SUBJECT: PRAIRIE ISLAND NUCLEAR GENERATING PLANT, UNITS 1 AND 2 - STAFF ASSESSMENT OF INFORMATION PROVIDED PURSUANT TO TITLE 10 OF THE *CODE OF FEDERAL REGULATIONS* PART 50, SECTION 50.54(f), SEISMIC HAZARD REEVALUATIONS FOR RECOMMENDATION 2.1 OF THE NEAR-TERM TASK FORCE (NTTF) REVIEW OF INSIGHTS FROM THE FUKUSHIMA DAI-ICHI ACCIDENT AND STAFF CLOSURE OF ACTIVITIES ASSOCIATED WITH NTTF RECOMMENDATION 2.1, "SEISMIC" (TAC NOS. MF3784 AND MF3785)

STAFF ASSESSMENT BY THE OFFICE OF NUCLEAR REACTOR REGULATION

RELATED TO SEISMIC HAZARD AND SCREENING REPORT

PRAIRIE ISLAND NUCLEAR GENERATING PLANT, UNITS 1 AND 2

Figure 3.3- 1 Plot of Staff's and Licensee's Base Case Shear-Wave Velocity Profiles for the PINGP Site

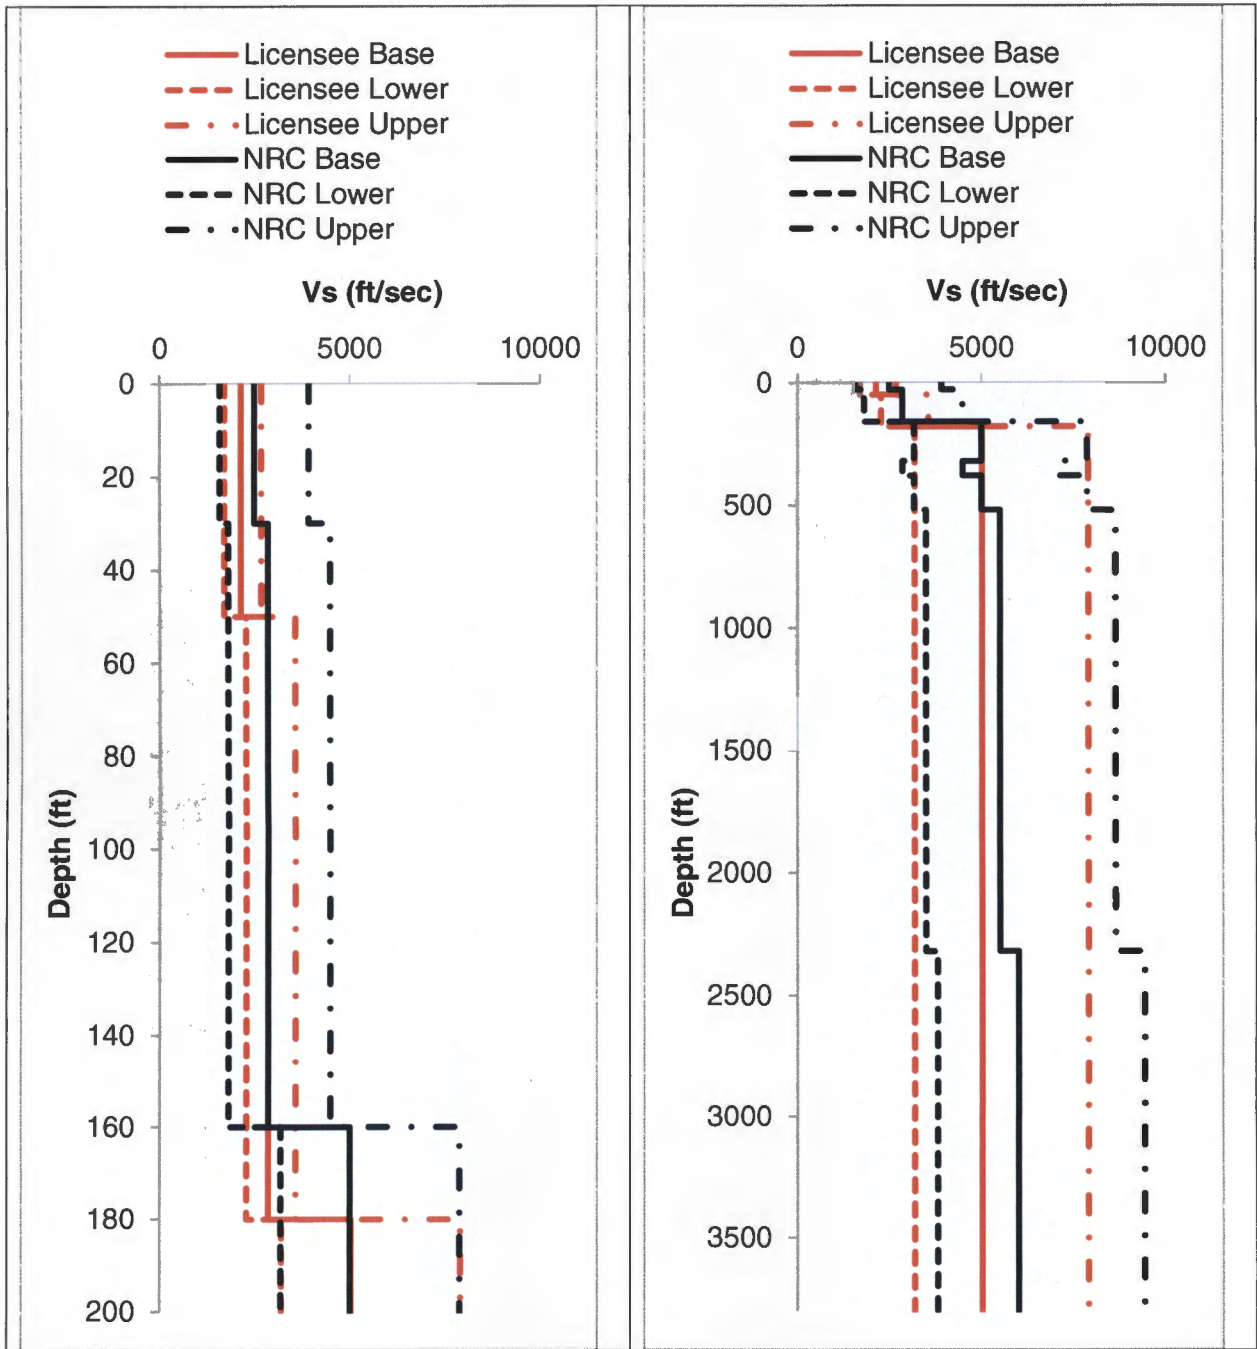
To characterize the subsurface geology, the licensee developed three site base case profiles. The middle, or best estimate, profile was developed using compressional-wave refraction surveys and assumed Poisson ratios. Upper and lower base case profiles were developed using a scale factor of 1.25 for the fill and glacial outwash and 1.57 for the firm sedimentary rock. The licensee noted that these scale factors reflect a log standard deviation of 0.20 and 0.35, consistent with guidance in the SPID. Figure 3.3-1 of this assessment shows the licensee's three shear-wave velocity base case profiles.

Site Parameter Study (GA-SPS, 1974). The NRC staff developed three separate profiles in order to capture the epistemic uncertainty in the modeled profiles. The staff's base case shear-wave velocity profiles are shown along with the licensee's base case profiles in Figure 3.3-1 of this assessment. The staff's shear wave velocity profiles agree well with those submitted by the licensee with only minor differences in the location of the interface between soil and sedimentary rock and the staff's selection of a broader range for the shear-wave velocity uncertainty in the upper 180 ft. [55 m] of the profile compared to the licensee's profile.

Figure 3.3- 2 Plot Comparing the Staff's and the License's Median Amplification Functions and Uncertainties for two input loading levels for the PINGP Site

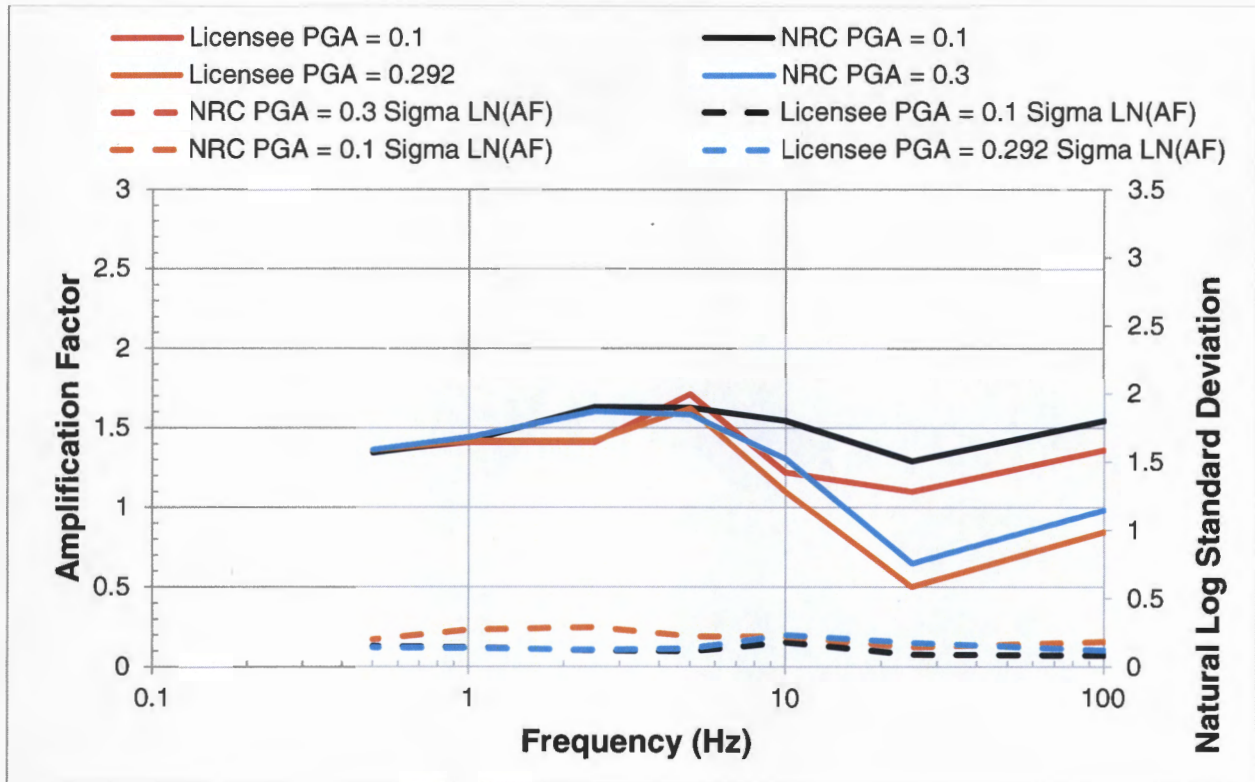
The median site amplification and associated uncertainty for 2 of the 11 loading levels are shown in Figure 3.3-2 of this assessment. Both the staff's and licensee's site amplifications are similar in shape with minor differences at peak amplification that are due to the differences in the velocity profiles and treatment of uncertainty for kappa between the staff's and licensee's analyses.

Figure 3.3-3 Plot Comparing the Staff's and the Licensee's Mean Control Point Hazard Curves at a Variety of Frequencies for the PINGP Site

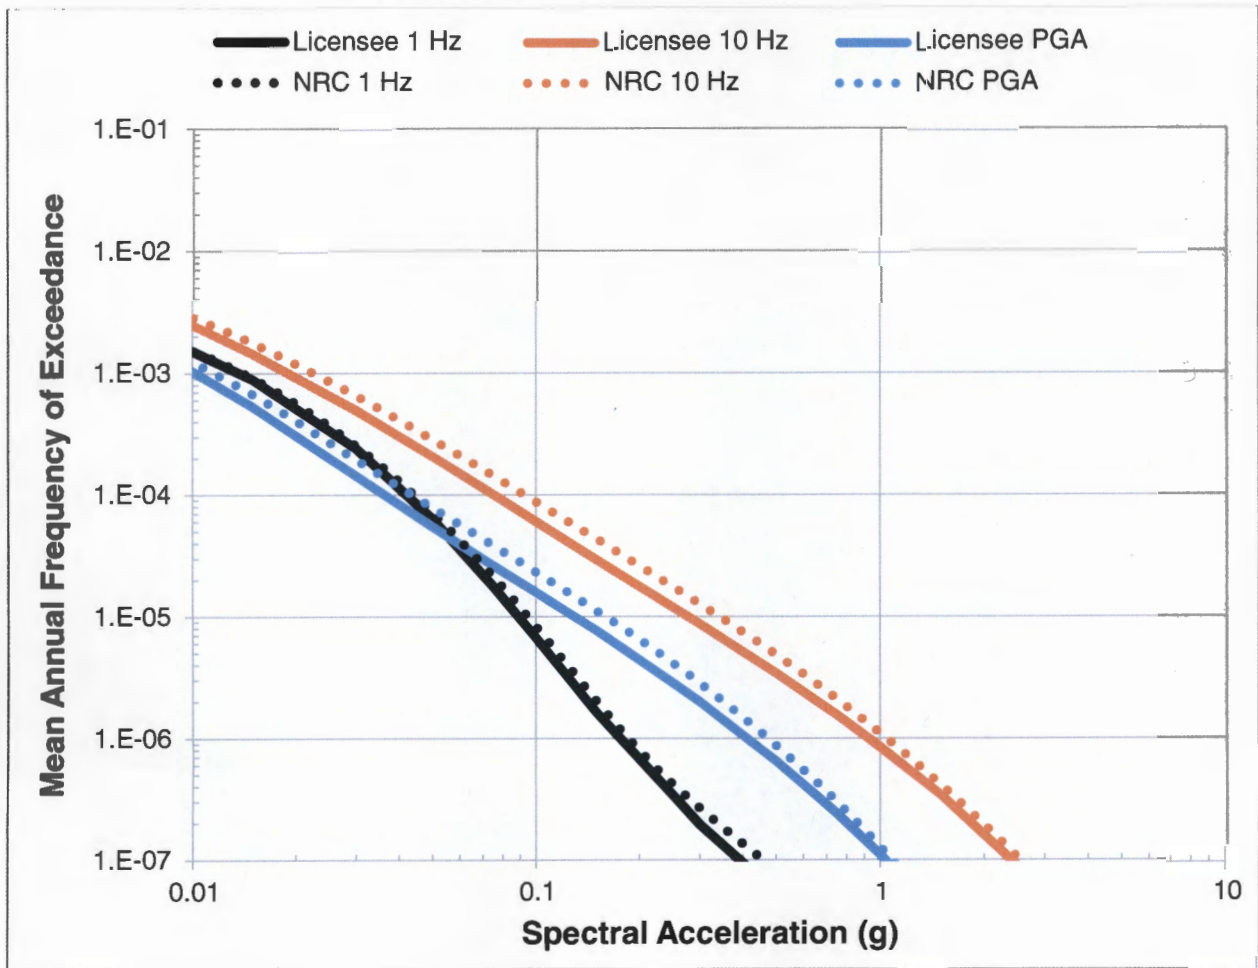
As shown in Figure 3-3-3 of this assessment, these differences in site response have only a moderate impact on the control point seismic hazard curves and the resulting GMRS, as discussed below. Appendix B of the SPID provides guidance for performing site response analyses, including capturing the uncertainty for sites with less subsurface data; however, the guidance is neither entirely prescriptive nor comprehensive. As such, various approaches in performing site response analyses, including the modeling of uncertainty, are acceptable for the 50.54(f) response.

Figure 3.4-1 Comparison of the Staff's GMRS with Licensee's GMRS and the SSE for the PINGP site

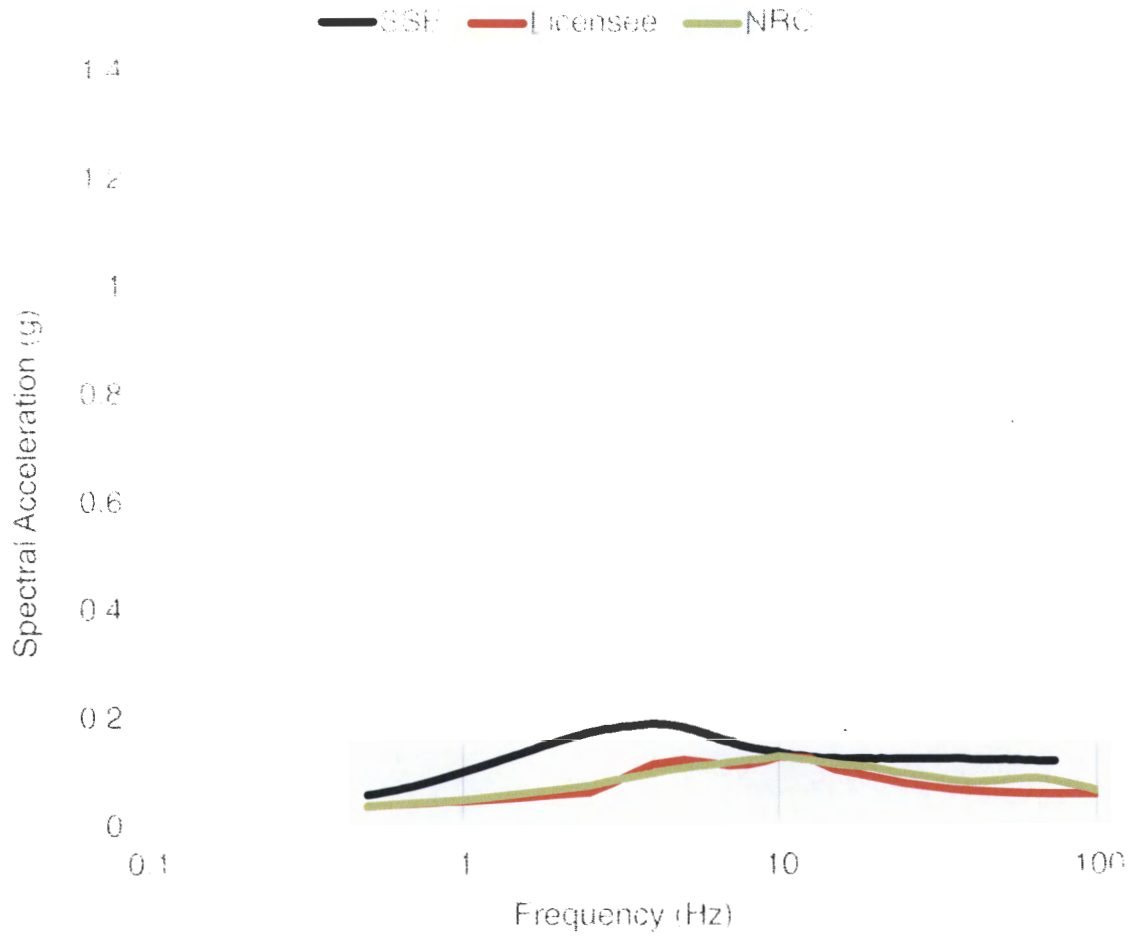
The NRC staff independently calculated the 10^{-4} and 10^{-5} UHRS using the results of its confirmatory PSHA and site response analyses, as described in Sections 3.2 and 3.3 of this staff assessment, respectively. Figure 3.4-1 of this assessment shows a comparison of the GMRS determined by the licensee to that determined by the NRC staff.

As shown in Figure 3.4-1, the licensee's and staff's GMRS shape are similar with minor differences for frequencies above 15 Hz. As described above in Section 3.3, the NRC staff concludes that these differences over this frequency range are primarily due to the differences in the site response analyses performed by the licensee and NRC staff. The NRC staff concludes that these differences are acceptable for this application because the licensee followed the guidance provided in the SPID with respect to both the PSHA and site response analysis for the PINGP site.
